**Re: Redoak/Capoak EIR/FSS Addendum Response Document
Third Submission, North Oakville East, Town of Oakville**

REDOAK/CAPOAK EIR/FSS ADDENDUM
RESPONSE DOCUMENT
AUGUST 12, 2020

RESPONSE TO CONSERVATION HALTON COMMENTS

FIGURE H-1A

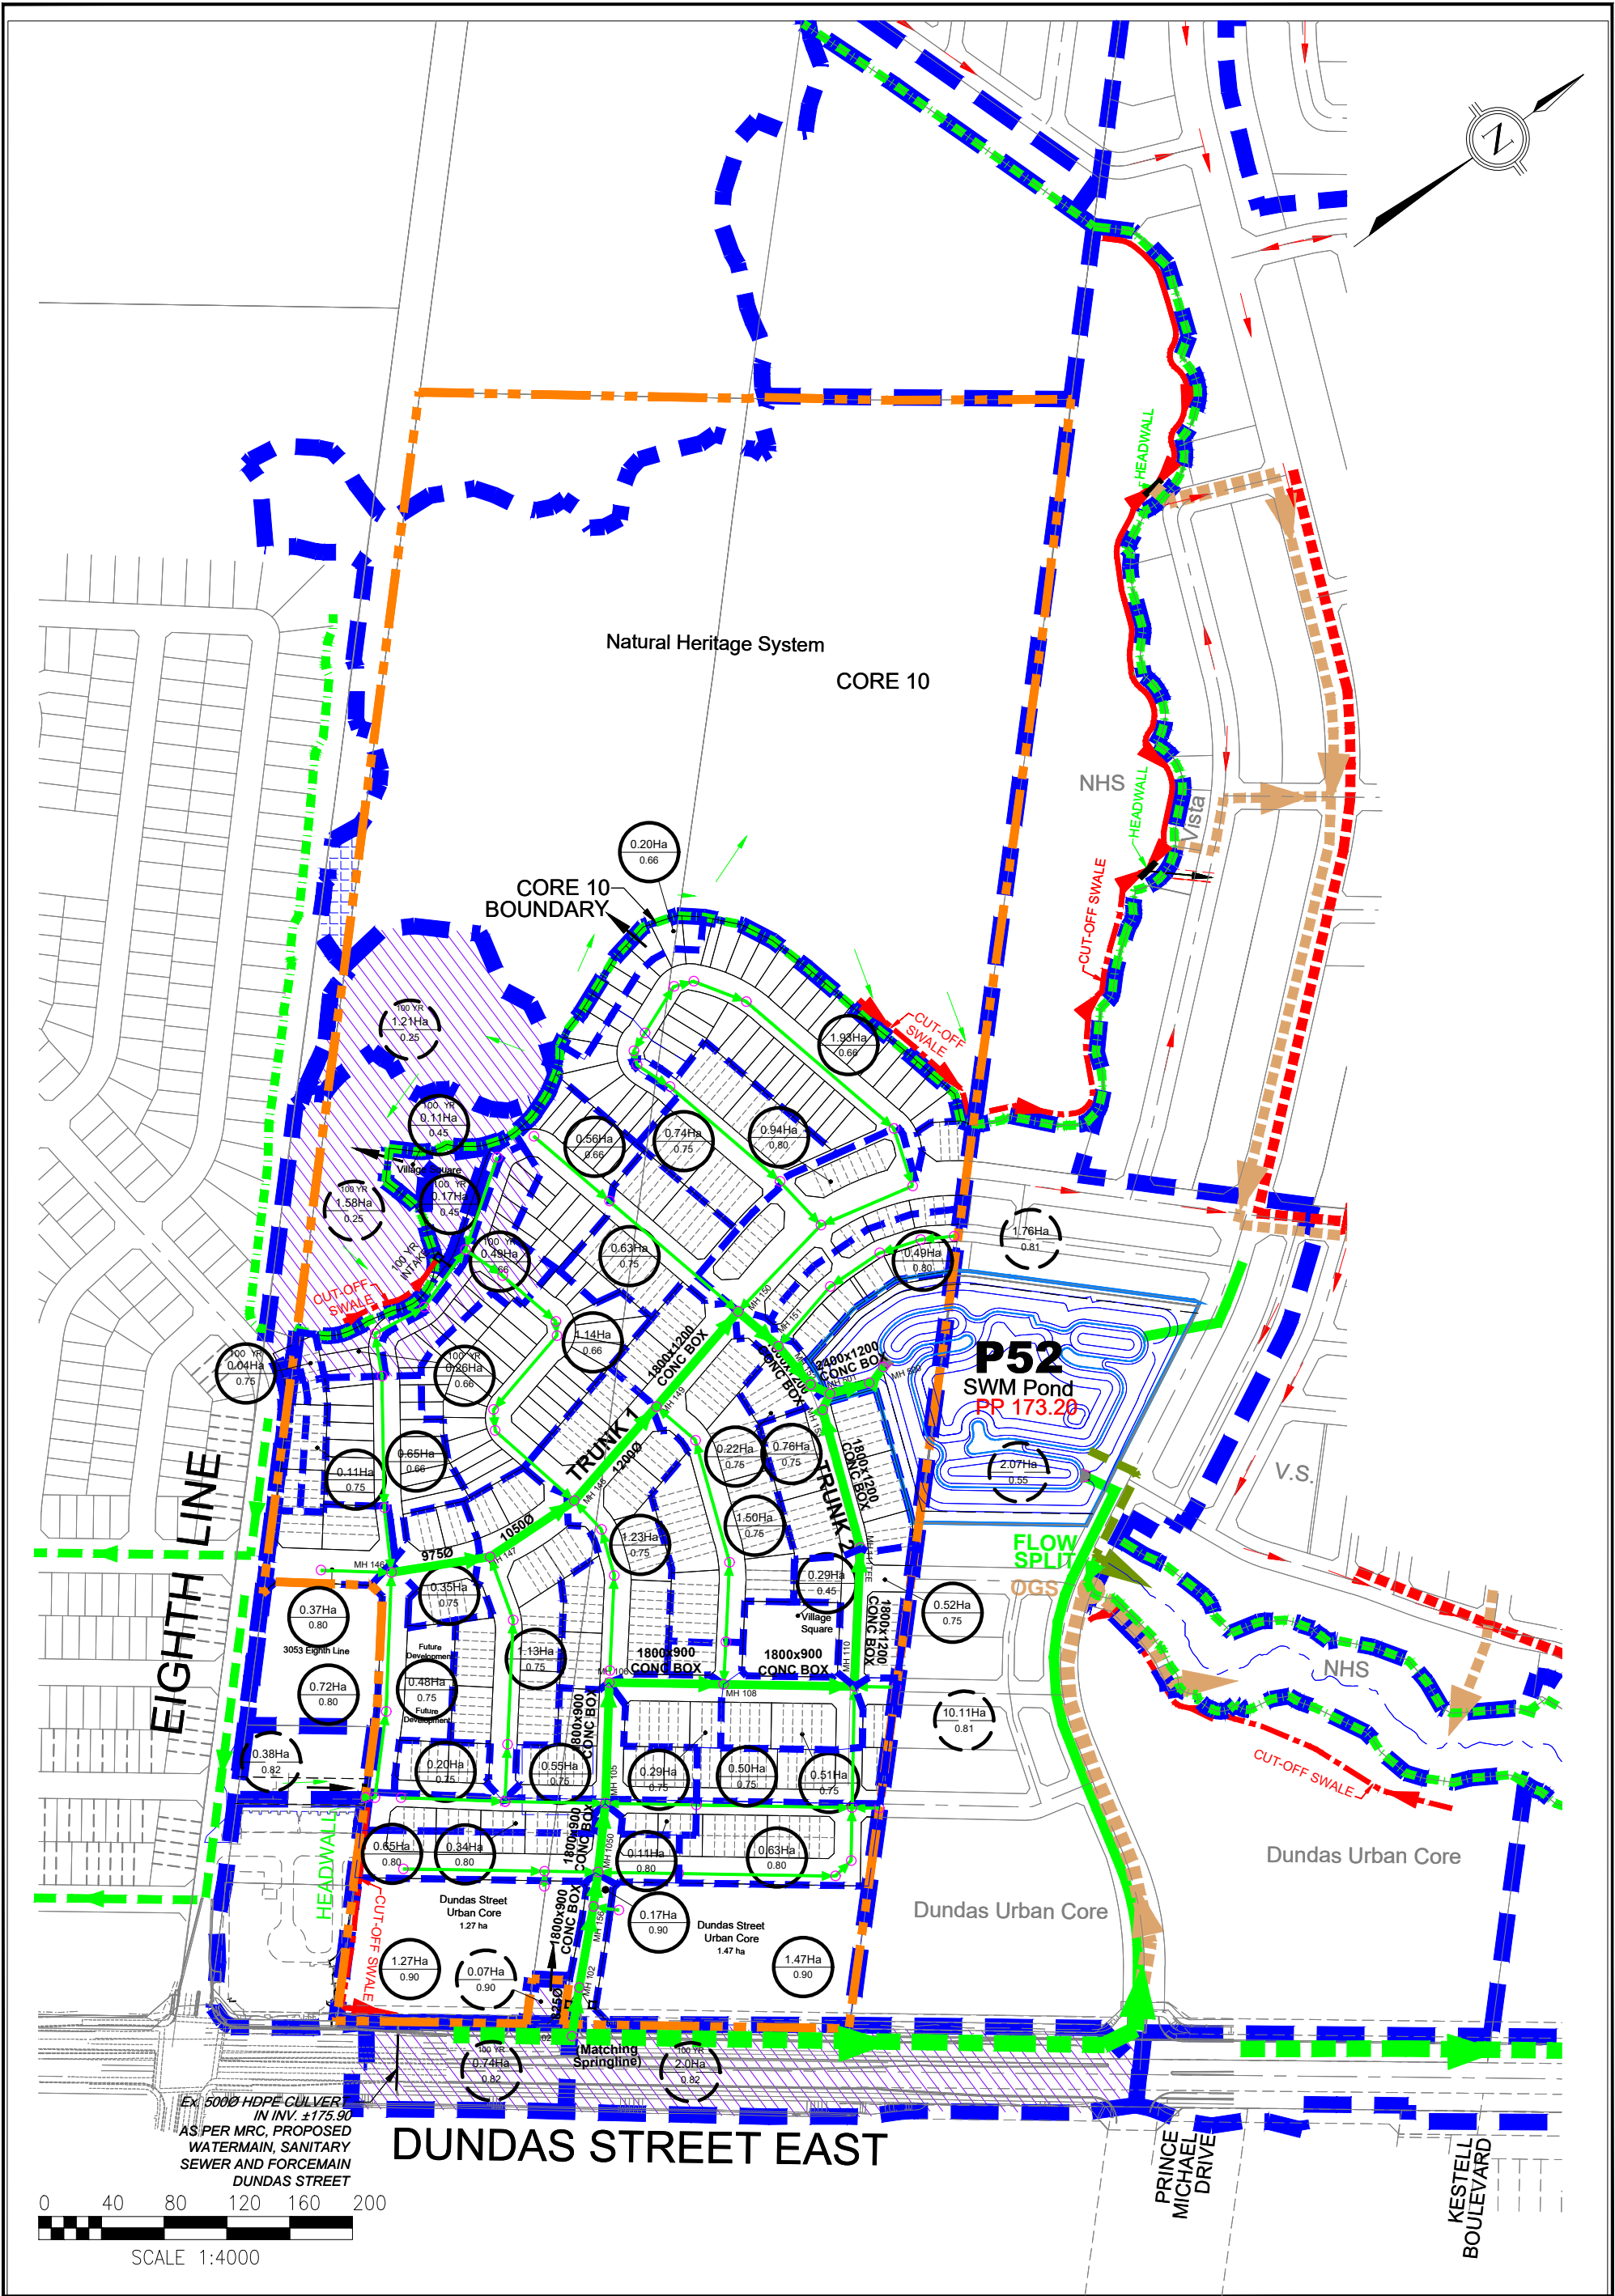
- b. In addition to the information requested, Appendix H-1 also contains Conceptual Servicing Option 1 and Conceptual Servicing Option 2, both labelled Figure H-1A. Two separate servicing options were not discussed in Section 7.8.1 and we would appreciate clarification of the options. Appendix H-5 provides the requested storm sewer design sheet however the design sheet does not match the detailed tributary plans, Figure H-1A. For example, the sewer from MH.105 to MH. 106 is 1200mm diameter at 0.3% whereas on Figure H-1A it is 1200 x 1800 concrete box sewer. Furthermore, the design sheet provided does not indicate substandard (0.15%) sewer slopes on Street A from Dundas Street discussed in Section 7.8.1 of the EIR/FSS Addendum. All sewers in the design sheet reflect 0.3% slope. We also note that Appendix H-5 is missing the cut-off swale sizing information. Further review and comments to follow under separate cover.

Response: We assume that this comment relates to Street B, not Street A. Section 7.8.1 has been revised to explicitly discuss the separate storm sewer connection options. See Tab D. Conceptual Servicing Options 1 and 2 are illustrated under separate figures within Appendix H; labelled H-1A and H1-B. The design sheets in Appendix H-5 have been revised to reflect the two conceptual servicing options, and include cut-off swale sizing information. See Tab F for revised Appendix H-5.
